DOCUMENT 00 90 00
ADDENDUM

ADDENDUM No.: 1

DATE: September 19, 2024

RE: VIROQUA HOUSING AUTHORITY
PUBLIC HOUSING PROJECT WI 118
200 PARK VIEW COURT
VIROQUA, WI 54665
PROJECT NO. 24012

E100

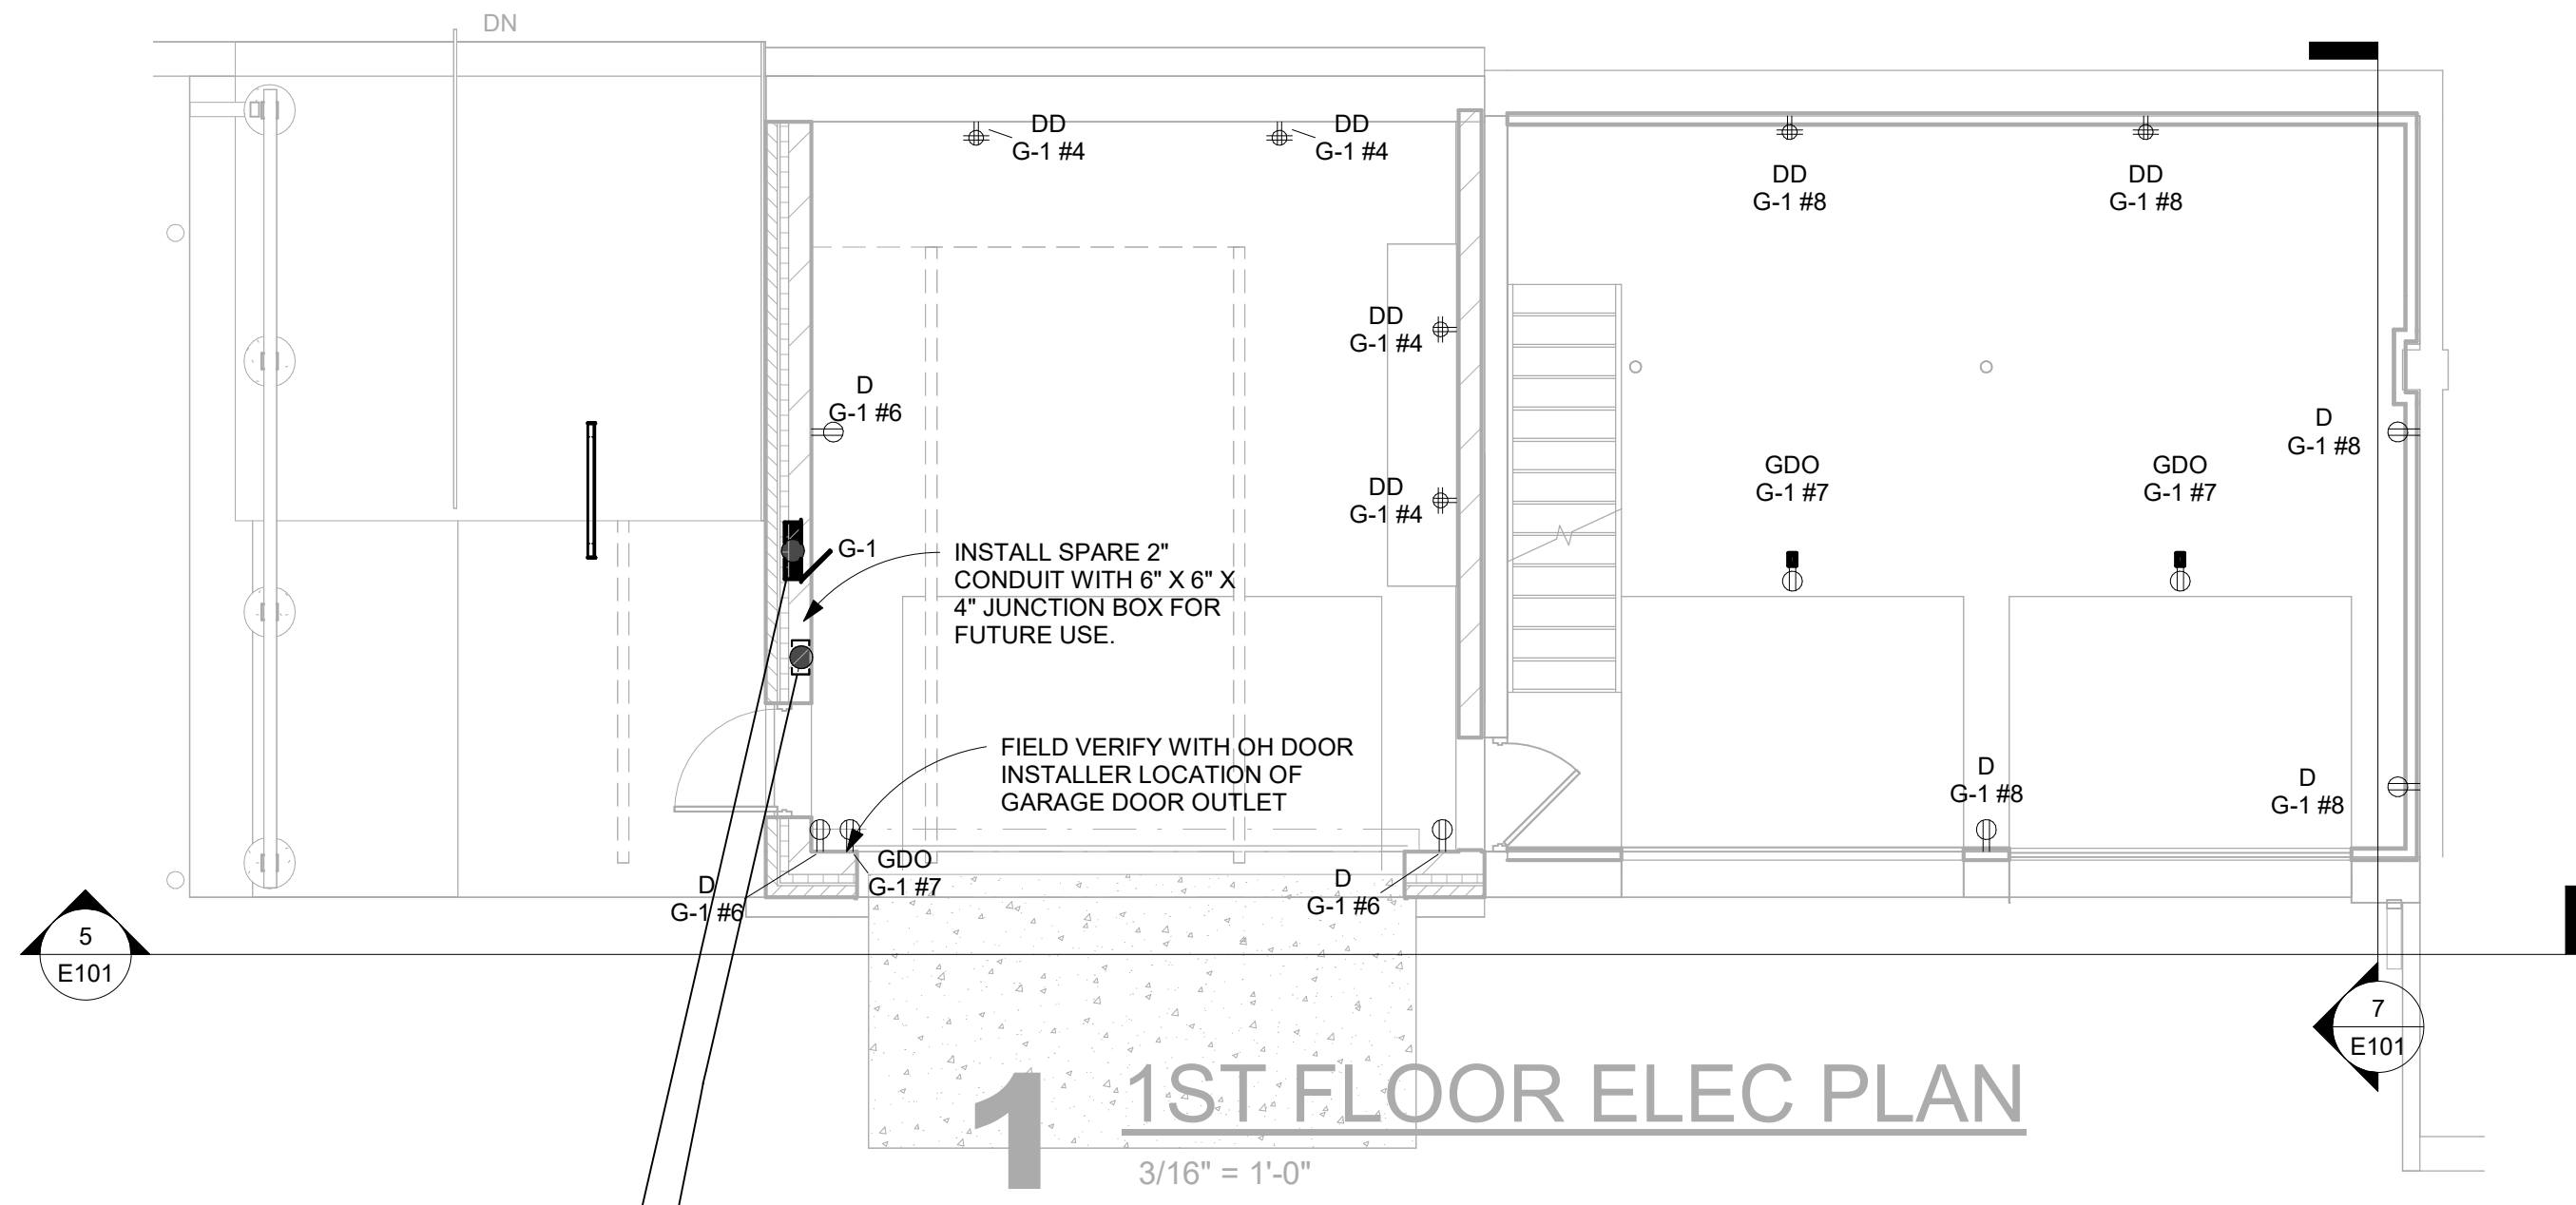
- b. Added Roof Elec Plan.
 - c. Added plan to show location of panelboard A1.
14. Sheet E101 ELECTRICAL PLAN 30"x42"
 - a. See the revised sheet included in this addendum. Disregard the previous version.

8 GARAGE FEEDER VIEW
1/4" = 1'-0"

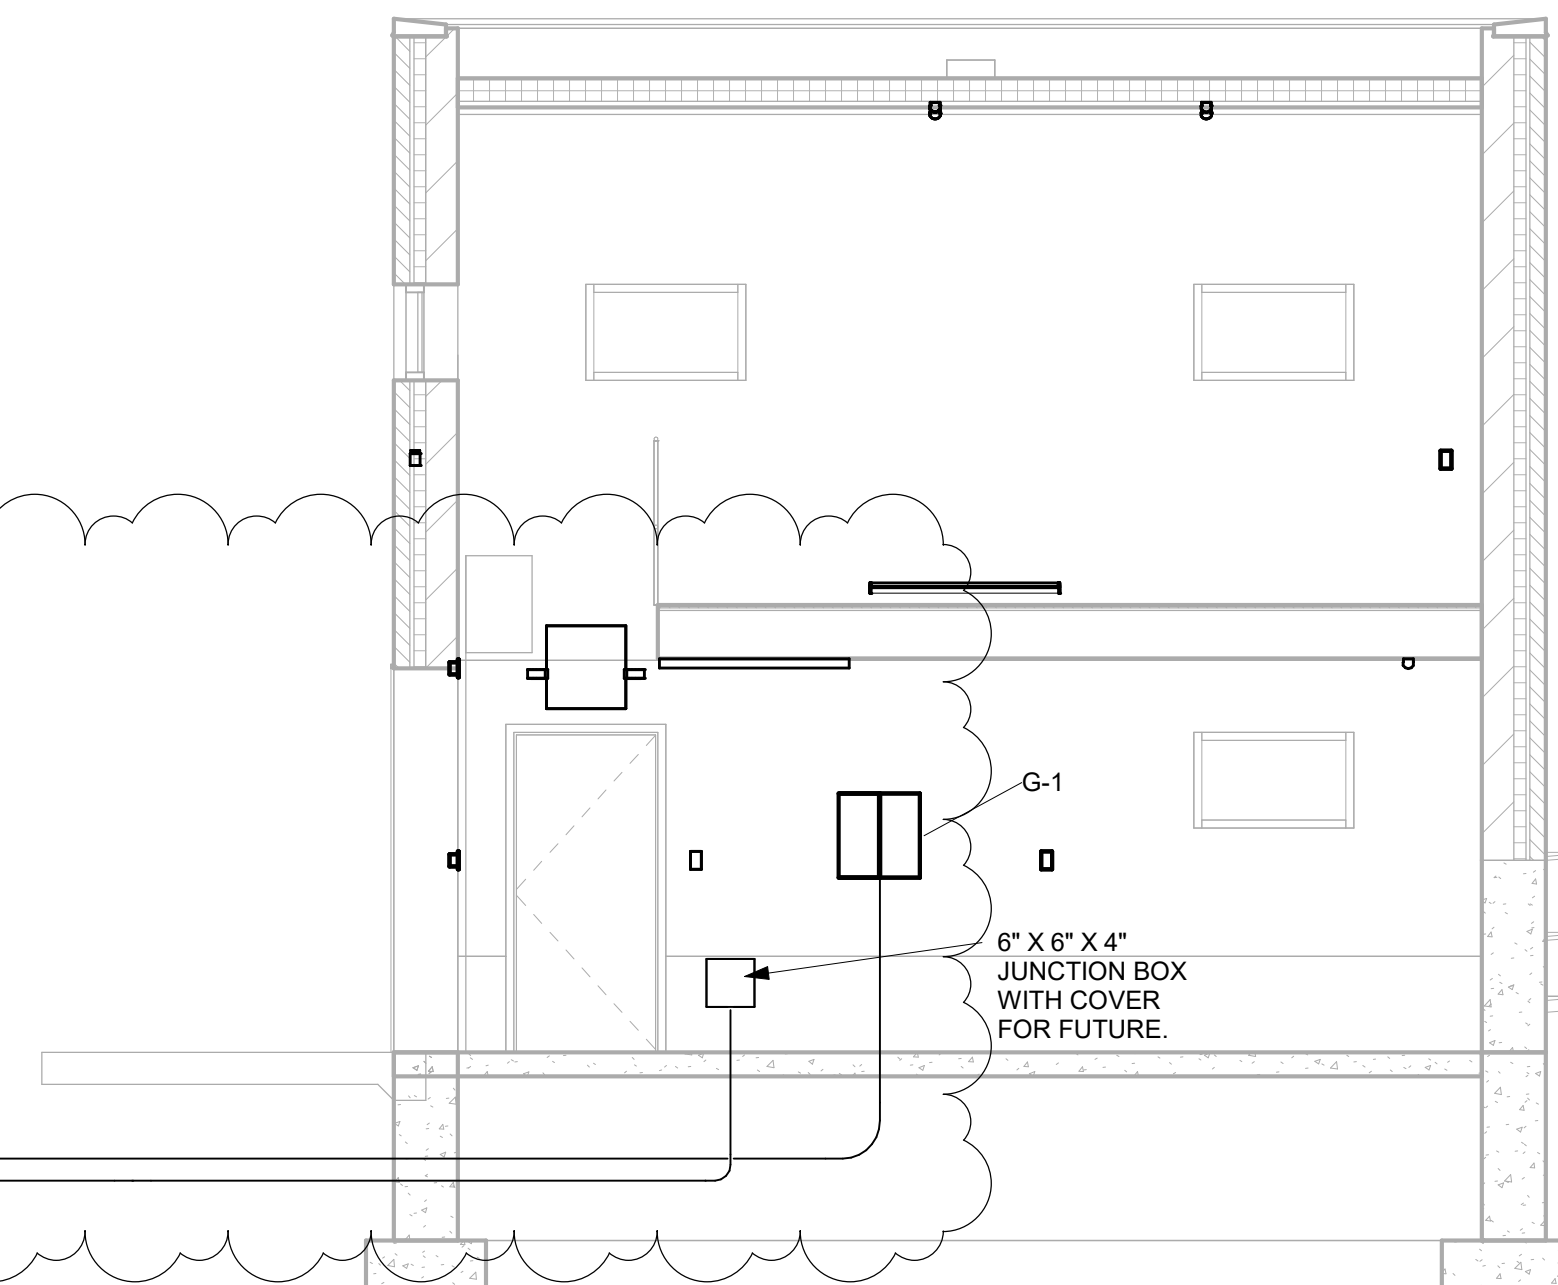
- b. Revised Lighting Fixture Schedule to remove I & J. -- NOT CLOUDED --
 - c. Revised detail 8 to show distinct conduits between the buildings.
